**CALIBRATOR CATHODE FOLLOWER
RESISTOR ADDED TO ASSURE
+100V CF OUTPUT LEVEL**

M1001

M1419

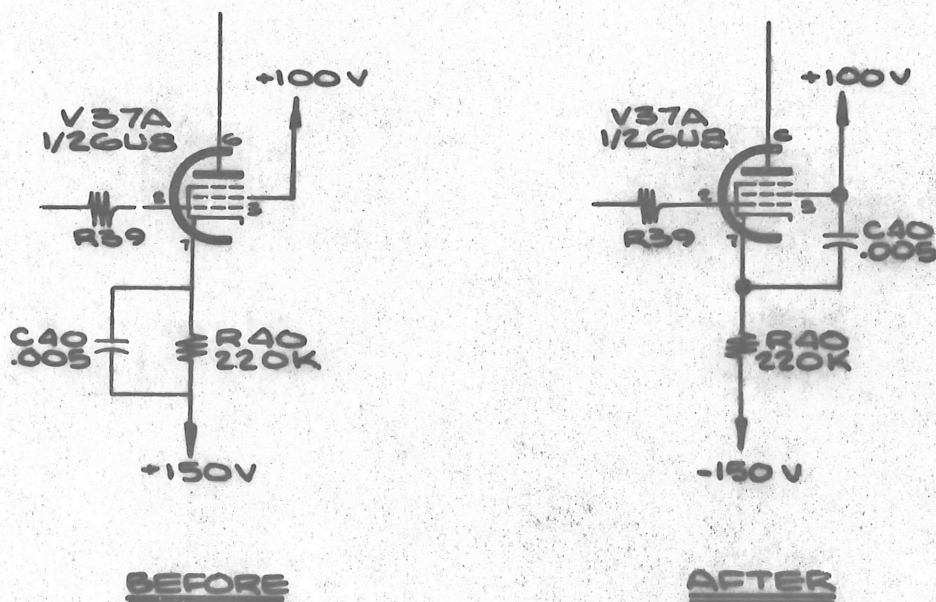
Adjustment of the Delayed Time Multiplier control would position the wrinkle on the horizontal axis at the point of delay pickoff. The Main Sweep Generator schematic will show C40 connected between pin 7 (cathode) and pin 3 (screen) of V37A. Pins 1 and 3 of V37A are jumpered to +100 V.

**-150V SUPPLY RINGING AND RIPPLE
REDUCED BY ADDED DECOUPLING**

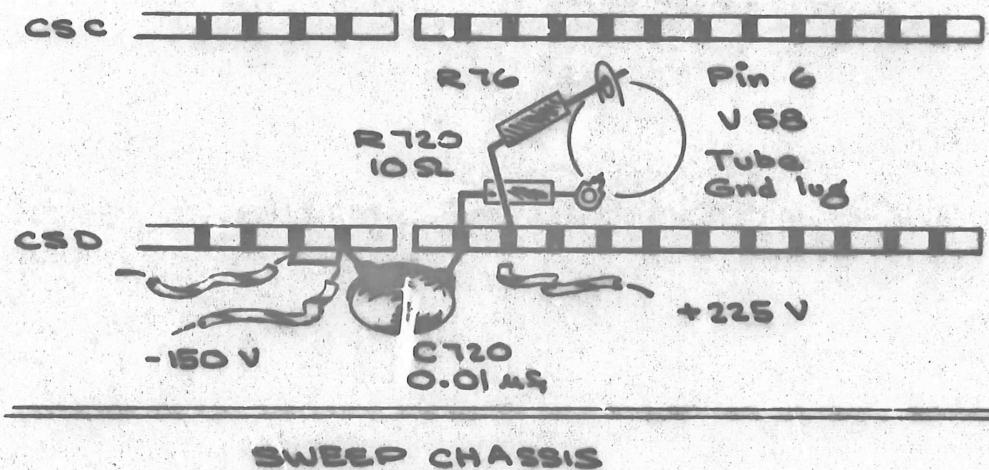
To reduce ringing and ripple in the -150V supply, a decoupling network was added between the -150V buss and ground. Although physically located on the Sweep chassis, the C720-R720 combination will be shown in shunt with C715 on the LV Power Supply schematic.

- Relocate one end of R76, a 47 Ω 1/2w resistor, and the +225v lead from CSD-12 to CSD-13.
- Unsolder and discard the wire strap between CSD-12 and CSD-13.
- Install R720, a 10 Ω 1/2w resistor, between CSD-12 and the ground lug directly below it on the tube socket of V58.
- Install C720, a 0.01 μ f discap capacitor, between CSD-11 (-150v) and CSD-12.

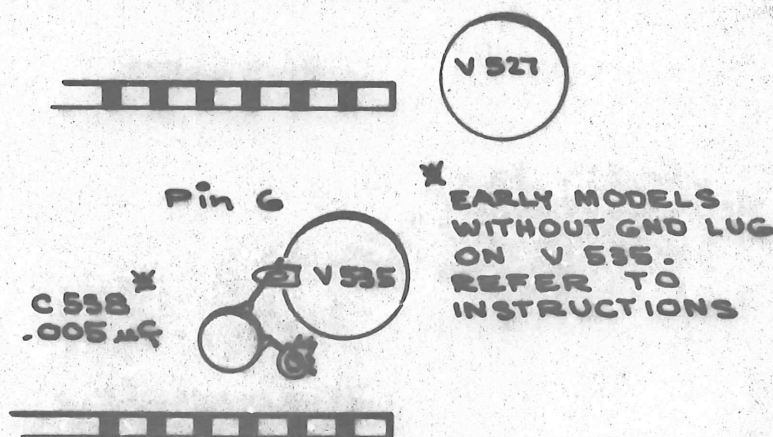
A decoupling discap capacitor C538 was added to reduce ringing resulting occasionally with a 53/54B plug-in. Fast risetime pulses would feedback into the filament circuit of the plug-in Input CF through the +500v wiring, causing input wrinkle approaching 4-5% at times. C538 was added between the plate (pin 6) of V535 and its ground lug.

TRIGGERING 'PRESET' POSITION ADDED TO STABILITY CONTROL

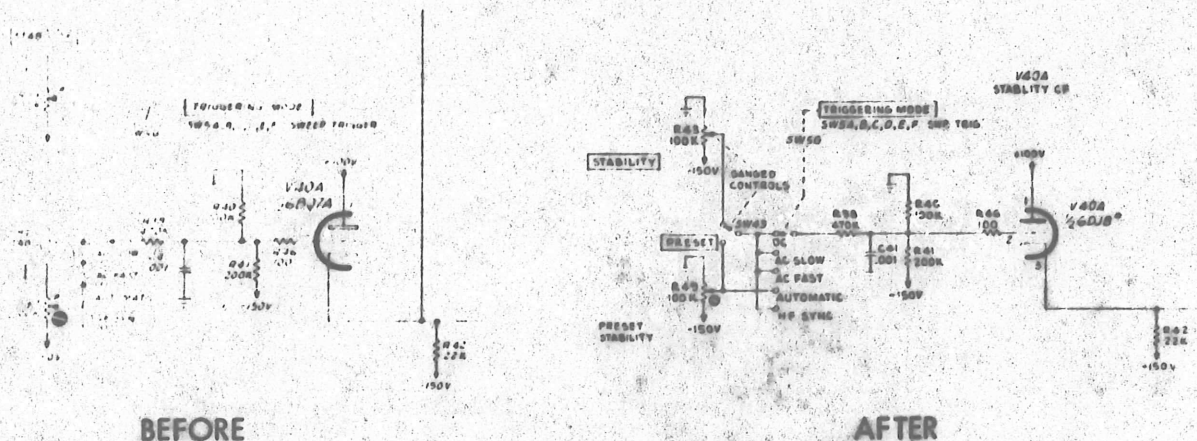
A 'Preset' position was added to the front panel stability control. This was to make use of the internal Preset stability adjustment, added by M1404 for the automatic mode, for all modes of triggering. In preset position, the front panel stability control is replaced by the internal preset stability control and only the triggering level control needs adjustment for proper triggering.

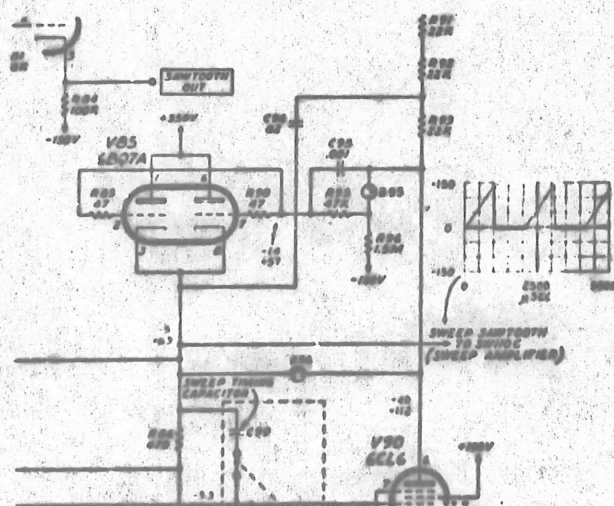
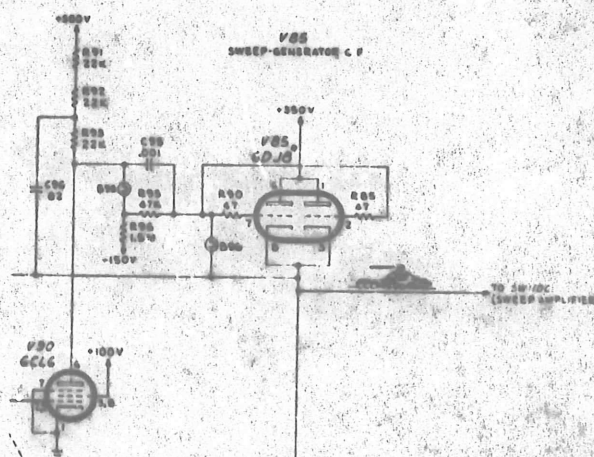
To eliminate the need for checked neon diodes in the Sweep Generator circuit, neon diode B96 was relocated from the junction of R93, C95 and the cathode of V85 to the junction of R95, R90 and the cathode of V85. With the change in circuitry for B96, it is not necessary that B95 be a checked neon. It was established that B287 of the Sweep Amplifier also required only a raw neon.
